ADDENDUM NO. 1
February 9, 2024

Dam Spillway Replacement Project
Lake Alvin Recreation Area
Lincoln County, South Dakota
GFP Project No. Alvi22Pa

STANDPIPE DETAIL
NOT TO SCALE

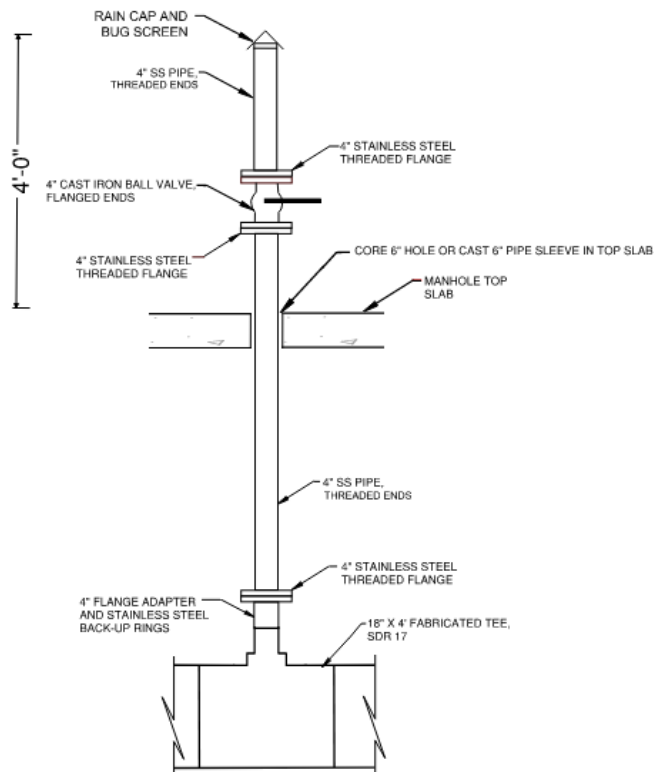
Item No. 2: **Question:** For the 4" stand pipe in the gate structures, what piping material should this be, and what should be at the very top of the stand pipe where it reaches ground level? Also, would a 4" inserta tee be an acceptable alternative to an 18"x4" tee fitting? This would be much more cost effective then having to have a 18"x4" HDPE tee fitting fabricated, and then there would be no need for the 4" HDPE stub out to have to transition to whatever the standpipe material needs to be.

Answer: The pipe material for the 4" stand pipe in the gate structures should be stainless steel. A 4" inserta tee will not be acceptable; provide the 18" x 18" x 4" tee as specified. The standpipe portion of Detail 2 on Page 18 of the Plans, shall be modified as follows:
